STANDARDS & SPECIFICATIONS SITE INSPECTION REPORT LEVEL 1 (FIELD REPORT)

Project Name:	Mountain Valley Pipeline	S&S Program:	Mountain Valley Pipeline (SS027)
Inspector:	Matthew Grant	Inspection Date:	Wednesday, July 24, 2024
Project Contact:	Cory Chalmers Brian Clauto	Project Contact Email:	cchalmers@equitransmidstream.com bclauto@equitransmidstream.com
Spread I: Franklin County	STA 14756- STA 14766 ATWS 372, 373, 1389	Site Conditions:	Wet

Fig. 2

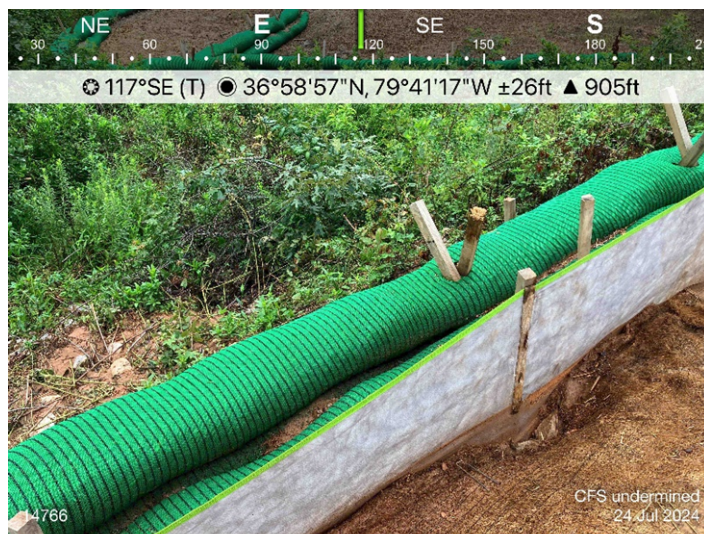
Description: CFS and P1 has been undermined.
